Date of Issue: March 31, 2017

Affected Publication: API Specification 6D, Specification for Pipeline and Piping Valves, Twenty-fourth Edition, August 2014

ERRATA 9

Page 35, **Section 11**, delete the text in the red box:

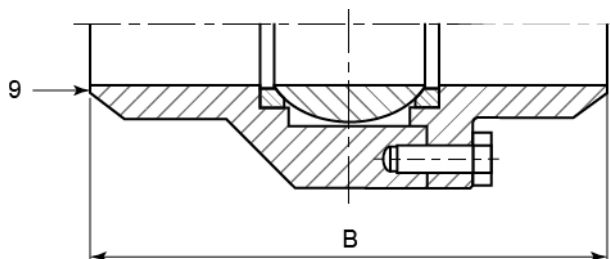
On valves whose size or shape limits the body markings, they may be omitted in the following order:

- 1) size,
- 2) rating,
- 3) material,
- 4) manufacturer name or trademark.
